# WDEP Shared Governance Committee Final Report

CLIMATE ACTION SHARED GOVERNANCE COMMITTEE

In July 2024, the University finalized the decision to pursue its original WDEP upgrade plan, against the recommendation of the WDEP Committee in its Preliminary Report (March, 2024).

**Figure 1:** Campus Steam Load Profile from Consultant Model

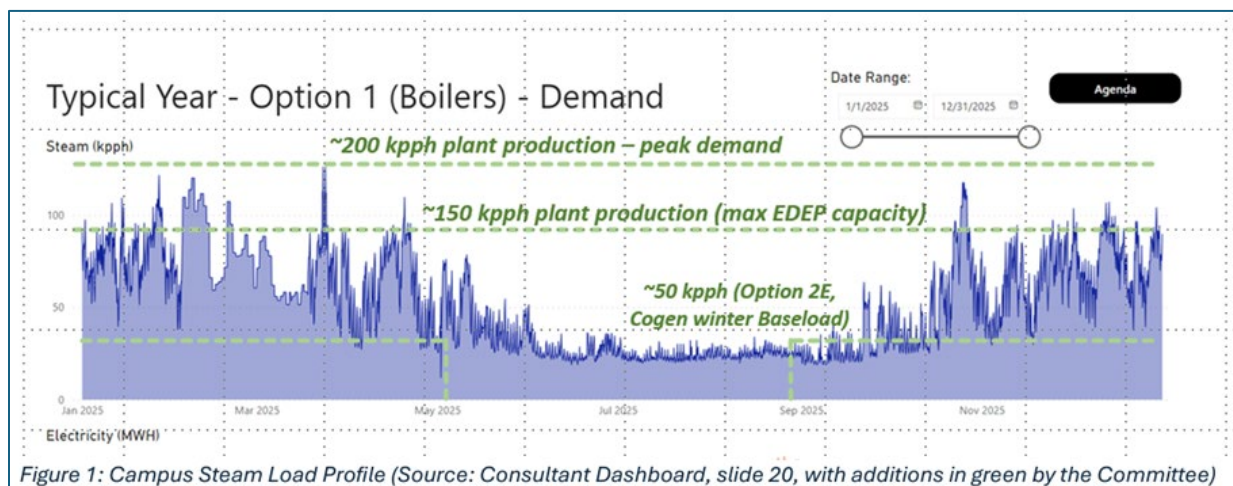
The Committee found that even in the event of failure of EDEP Boiler 1 (100 kpph), the University would have 150 kpph available through other boilers at up to 100% capacity factor (those are EDEP Boiler 2, and the newly installed WDEP Boiler 3 under Option A1). Therefore, to meet peak demand of 200 kpph, the University would only be required to satisfy the area of the load curve between 150 kpph and 200 kpph. The Committee consulted a figure from the University’s steam load profile (See Figure 1 below). This figure demonstrates the relevant area is smaller “by orders of magnitude” relative to the capacity afforded by the CTG’s at 10% capacity factor (p. 15).

- First, the University has not provided any documentation to back up its claim for 200 kpph peak Winter demand. The figures presented to the Committee by the University used a building-demand model developed by the University’s consultant. That model demonstrated peak demand of only 126 kpph (Mar. 25, 2025).<sup>11</sup> The Committee recognized that due to transmission losses, building demand (the model figure) is lower than peak generation required at the plant, which is the relevant figure for resilience analysis. However, the University has never presented the Committee with any documentation regarding its claim for plant-side peak demand of 200 kpph. The Committee flagged the lack of documentation in its Preliminary Report (p. 18) and made a formal request for documentation. See WDEP Shared Governance Committee, Additional Questions, p. 1 ([here](#)). The University did not respond to that or future requests.

- Second, the Committee highlighted that the 200 kpph figure ignores the University’s plans to reduce energy demand by 30% by 2030. See Additional Questions, p. 2.

- Third, the Committee highlighted that simple demand-side measures could be used to reduce the 200 kpph load, like recalibrating thermostat set-points or turning off non-essential demand in the unusual circumstances of an N+1 event coinciding with a peak-demand day. The Committee made formal requests for information on future energy demand and thermostat set point data. See Additional Questions Document. The University did not respond to those requests.

- The University’s failure to provide the necessary figures and documents is of special significance because the firm capacity gap the University claims is quite small relative to peak demand (only 7%, i.e., 14 kpph out of 200 kpph).

**Figure 2: Xcel Emission Forecast Relative to City of Boulder Benchmarks<sup>23</sup>**

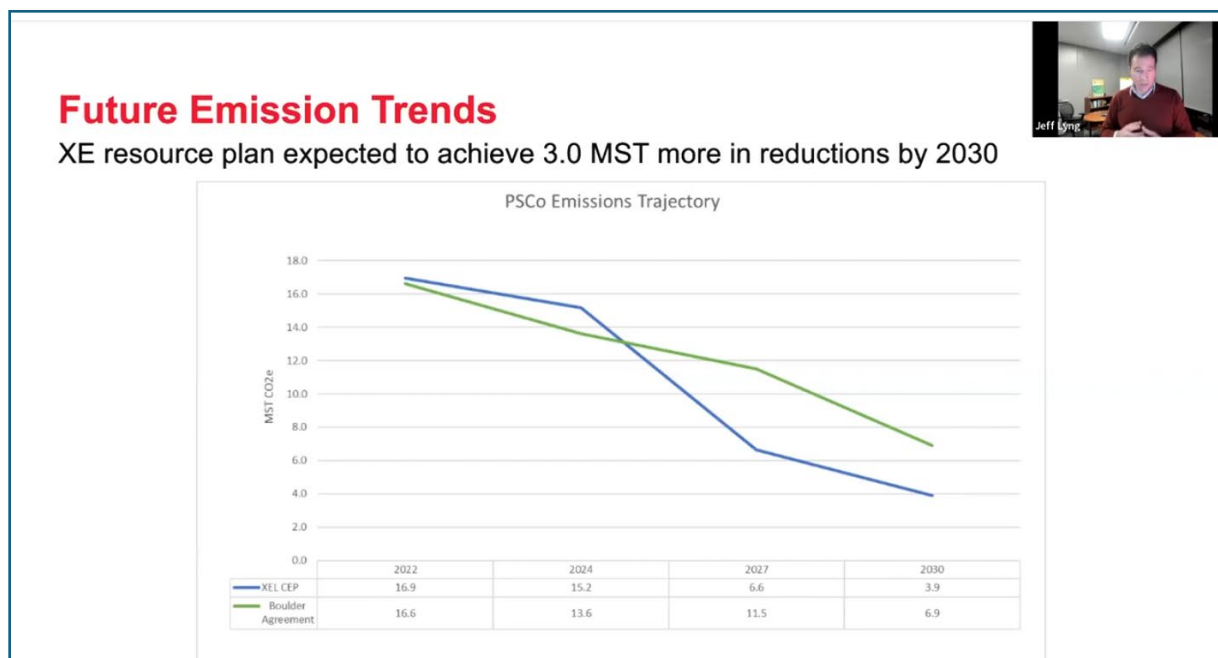
While the University is correct to note that Xcel missed its 2024 City of Boulder benchmark, that miss is not indicative of Xcel’s inability to meet its statutory 2030 target. Utilities’ progress towards targets is not linear, especially over short horizons. Meanwhile, the University seemingly missed encouraging indications regarding Xcel’s progress. Earlier this year (2024), Xcel provided a forecast indicating that it will significantly outperform the 2027 City of Boulder benchmark, as well as its statutory 2030 Clean Energy Plan target (see [here](#), around 40:00). That recent Xcel forecast is of special significance because it incorporates the Colorado PUC’s approval of Phase II of Xcel’s Clean Energy Plan (that plan approves new renewable capacity). Xcel’s forecasts translate to achieving 80% emissions reduction target as early as 2027 (3 years ahead of the 2030 target), and nearly 90% reduction by 2030.<sup>22</sup> A screenshot of the forecast is included as Figure 2 below. The green line represents the Boulder agreement benchmarks, and the blue line represents Xcel’s performance (including 2027 and 2030 forecast). The large area where the blue is below the green line represents the forecast for target overperformance by Xcel.

**Figure 4:** The University’s LCCA for Option 1 and Option 2E (2025-2055)

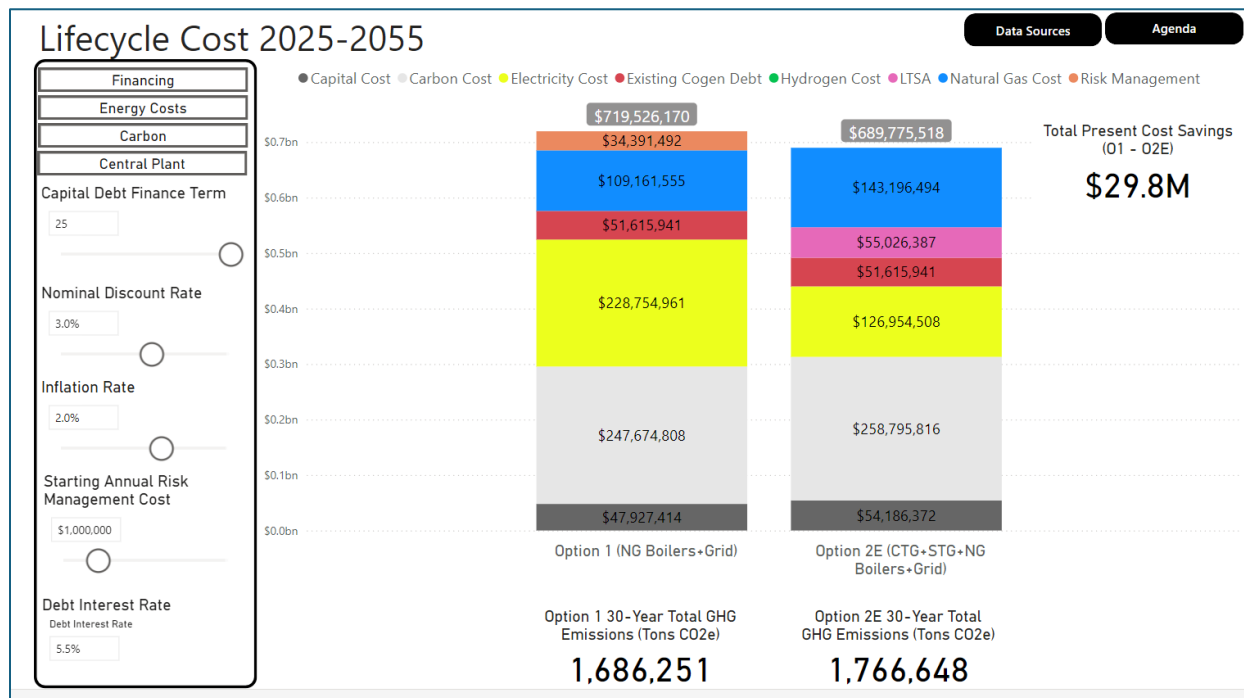
One key concern highlighted in the Committee's Preliminary report was the use of contradictory assumptions regarding baseloading of the new turbines under Option 2E (see discussion in Section B.2. above). From an emissions standpoint, the University claims that it will phase-out its use of cogen for baseloading to limit the increase in emissions of Option 2E relative to BAU. Meanwhile, from a financial standpoint, the University's analysis of Option 2E runs until 2055 (see screenshot below).

These contradictory assumptions are problematic because the savings in lifecycle cost identified in the consultant’s model derived precisely from the operation of the cogen (and corresponding savings in Xcel utility bills). Graphically, this can be seen in the fact that the yellow and blue boxes (electricity and gas cost respectively) are higher for Option 1 (and hence, 1A) than they are for Option 2E (about \$337 million to \$269 million, i.e., \$68 million difference). The University faces a tradeoff between increasing its emissions and trying to reduce its utility bill. As discussed in the Preliminary Report (p. 1), Under the University’s Energy Master Plan (“EMP”, 2021), the University intended to refrain from baseloaded cogeneration once the emissions factor of the grid and boiler heat is lower than cogeneration. According to the University’s own model, that point is expected to be reached as early as 2029. The only lifecycle cost advantages that Option 2E can have after 2029 are a direct result of departing from the EMP and increasing emissions relative to BAU. Thus, if the University abided by the EMP, there should no meaningful lifecycle cost advantage to Option 2E after 2029. The Committee finds that the lower upfront cost of Option A1 (especially when considering uncertainty over the tax credit) would likely lead to an overall lifecycle cost for Option A1 that is similar or lower than Option 2E.

**Figure 5:** The University’s LCCA for Option 1 and Option 2E (2025-2045)

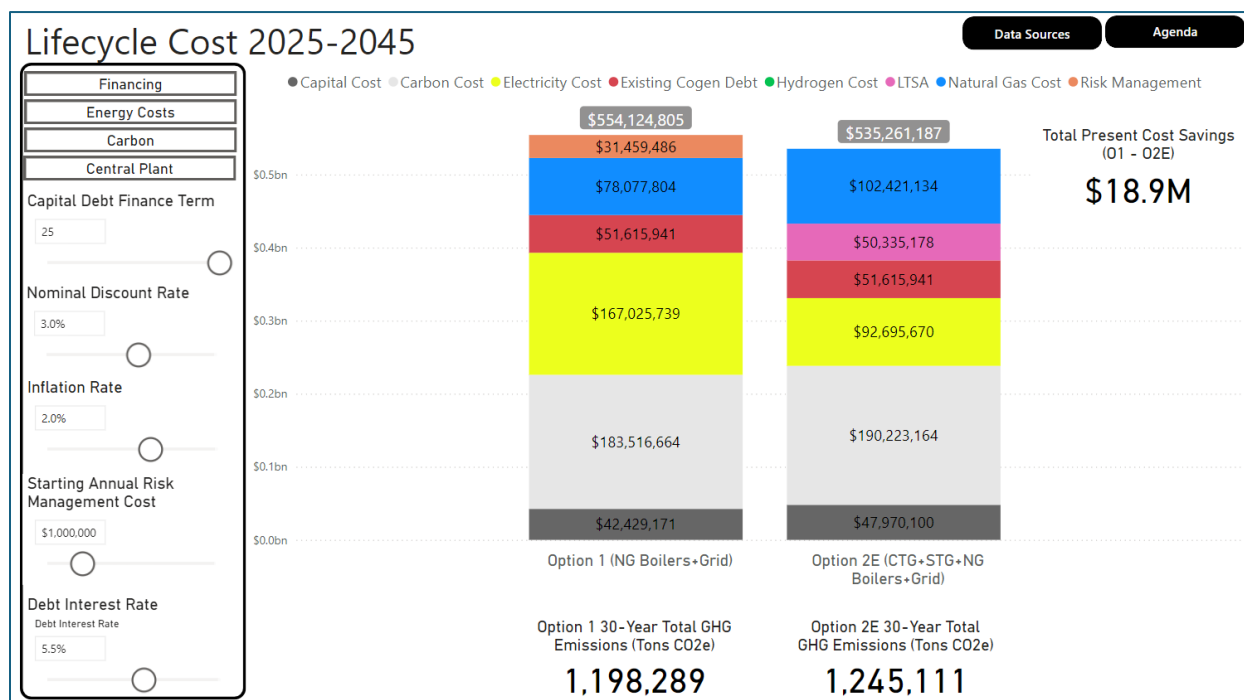
The consultant also performed a 20-year lifecycle cost-analysis for 2025-2045. This analysis found a smaller cost advantage to Option 2E over option A1, only \$19 million rather than \$30 million. Consistent with the Committee’s analysis, the 2025-2045 analysis has a smaller utility bill difference: electric and natural gas cost (sum of yellow and blue boxes) equals \$245 million for Option 1 and \$194 million for Option 2E. That \$51 million cost difference (2025-2045 analysis) is \$17 million smaller than the \$68 million difference in the 2025-2055 analysis. That \$17 million amount accounts for nearly the entire difference between the shorter-term and longer-term analysis (\$19 million). Using the same logic, if the University chose to phase-out the baseloading of cogen prior to 2045, it would reduce the cost saving it claims even further.
